Cass Clubhouse Museum RFQ No.: DNR 209014 Addendum Bulletin No. 1

# <u>DEPT. of Natural Resources</u> <u>Cass Scenic Railroad</u> <u>Clubhouse Renovation</u>

## AAI PROJECT NO.: 0404039.01 DNR-209014

September 26, 2008

# SECTION @ ROOF RIDGE VENT (TYPICAL)

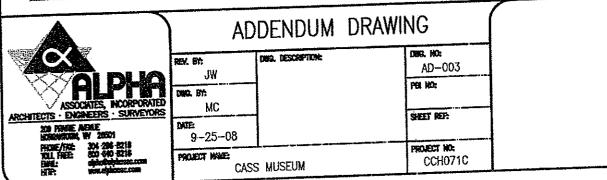
O4 Sheet A-5.01, Dtl. 9/A-1.09 Section at Roof Ridge Vent
Add: Note as shown on the attached Addenda
Drawing AD-001. This was also a hand out at the Pre-Bid Meeting.

Add: Note:"Extend ridge vent to end of gables for finished look. Do not cut vent slot beyond building envelope."
